# CITY OF ALBUQUERQUE

**RE: Aloft Hotel**  
**1501 Aircraft Ave. SE**  
**Conceptual Grading & Drainage Plan and Drainage Report**  
**Engineer's Stamp Date: no stamp**  
**Hydrology File: M15D057**  
**Case # HYDR-2025-00219**

Based upon the information provided in your submittal received 06/17/2025, the Grading & Drainage Plans are not approved for Demo Permit and/or Grading Permit. The following comments need to be addressed for approval of the above referenced project:

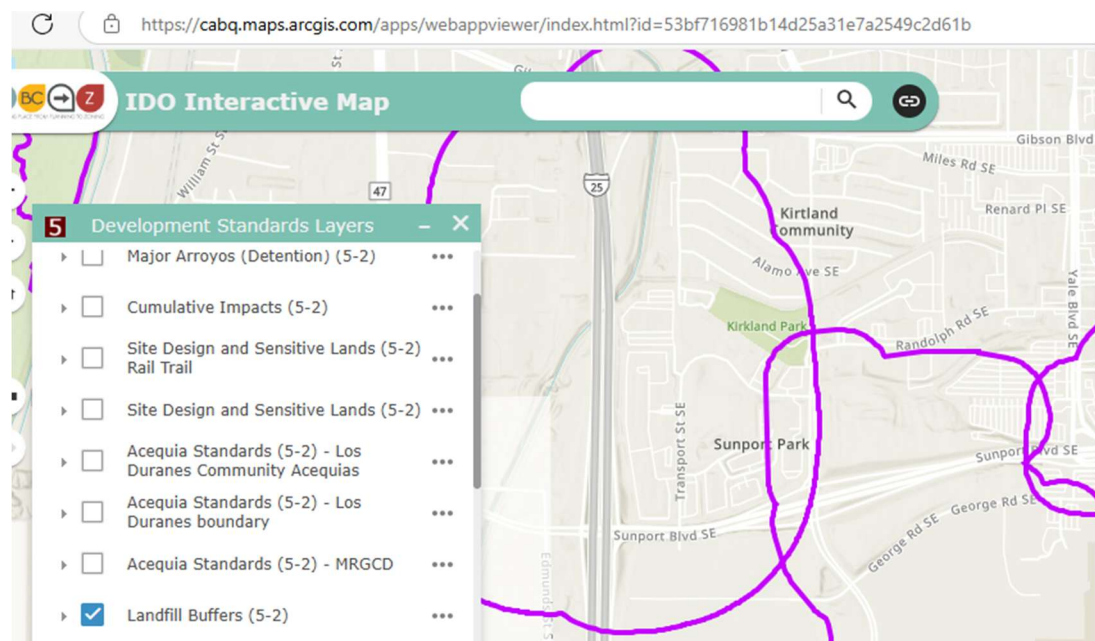
11. G&D Plans – Sheet 10 – Proposed Drainage – Please correct the Total from 13.12 acres to 16.125 acres to match the values shown in the tables.
12. Please note that a portion of this development appears to be inside multiple Landfill Buffers. Per the IDO, a Landfill Gas Mitigation Approval is required by the Environmental Health Department.
